3.0 LIMITING CONDITION FOR OPERATION (LCO) APPLICABILITY

STP DEP 16.3-1

Figure B 3.3.4.1-1, ATWS and EOC-RPT INSTRUMENTATION CHANNELS

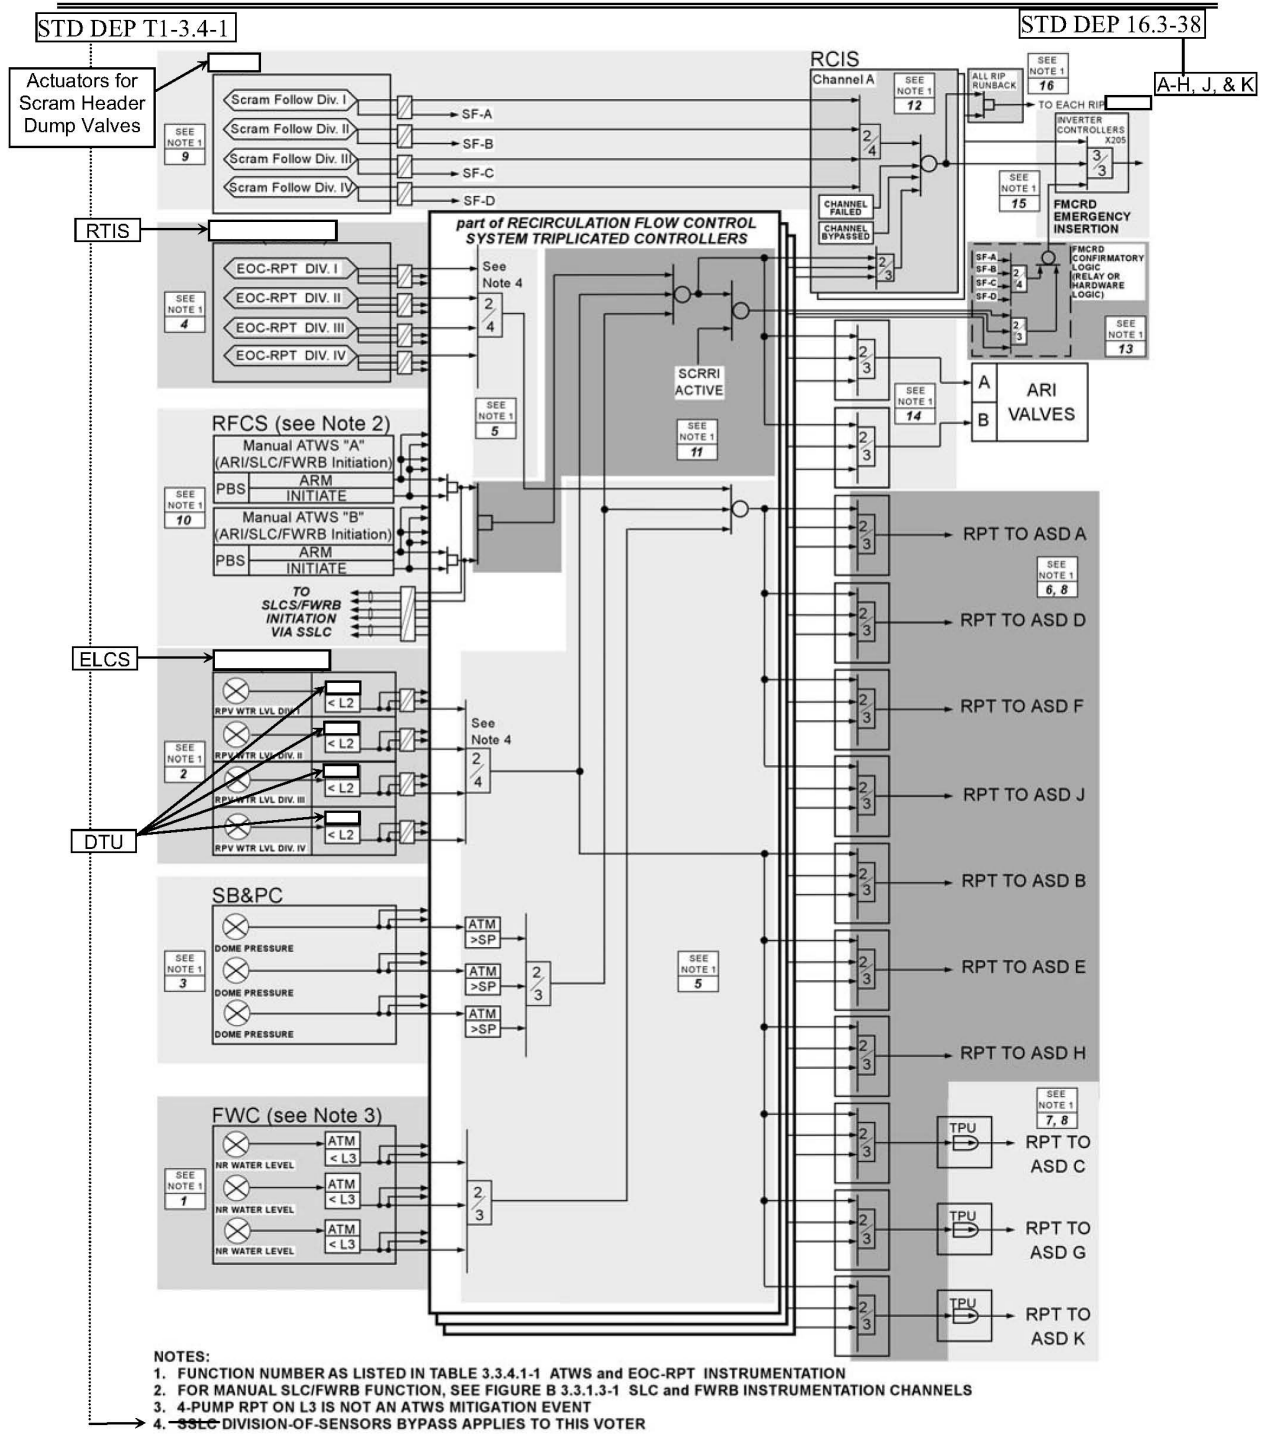
The Feedwater Reactor Vessel Water Level - Low, Level 3 data originates from three level transmitters that sense the difference between the pressure due to a constant column of water (reference leg) and the pressure due to the actual water level (variable leg) in the vessel. Data from the three level transmitters are received by the three FWC controllers ~~via the three plant multiplexing systems~~. Level 3 trip data is generated in the FWC and the voted results from all three FWC controllers ~~is~~ are transmitted to each of the ~~three~~ RFC controllers by three separate signals. The RFC controllers ~~which~~ use 2/3 logic to create RPT data.

The SB&PC Reactor Steam Dome Pressure-High data originates from three wide range and three narrow range pressure transmitters that monitor pressure in the reactor steam dome. Data from the ~~three~~ pressure transmitters are received by the three ~~SB&PC~~ controllers via the ~~three~~ plant multiplexing data communication function systems. Either the three wide range or the three narrow range ~~data values~~ selected within the SB&PC controllers for all three sensors are received by each of the three RFC controllers which use 2/3 logic to create ATWS-RPT data.

Four channels of Turbine Steam Flow Rapid Shutoff EOC-RPT are available and ~~three~~ are required to be OPERABLE to provide confidence that no single instrument failure can preclude an EOC-RPT from this Function on a valid signal. This Function is considered to be OPERABLE when an EOC-RPT trip signal originating in each of the four ~~SSLC~~ RTIS division channels is received by all three of the RFC controllers.

The trip actuation devices in the ASD are required to be operable in order to complete the RIP trip Function. Each ASD uses signals from the RPT Function in all three of the RFC controllers. A trip condition from any two of the controllers will cause a trip of the associated RIP. ~~Three~~ One channels of pump trip actuation per ASD must be OPERABLE when ATWS mitigation or EOC-RPT is required to be OPERABLE ~~to provide confidence that no single instrument failure can preclude an RPT from this Function on a valid signal.~~

~~The~~ For Reactor Internal Pumps C, G, and K, the ASDs provide timers to cause a small delay before interrupting the devices that provide power to the RIPs. One timer channel and load ~~driver~~ interrupter in each ASD (for RIPs C, G, and K) is available and required to be OPERABLE when ATWS mitigation or EOC-RPT is required to be OPERABLE. The Allowable Values are chosen to cause a trip of the pumps in a timely fashion while minimizing the effects of the transients caused by the pump trips.

The RFC must transmit ATWS-ARI initiation data to the RCIS and the FMCRD Insertion Confirmatory Logic. Three channels of this Function are required to be OPERABLE when ATWS mitigation is required to be OPERABLE to provide confidence that no single instrument failure can preclude an ATWS-ARI initiation from this Function on a valid signal. A channel of this Function is considered to be OPERABLE when ~~an~~ the ATWS-ARI initiation signals originating in each of
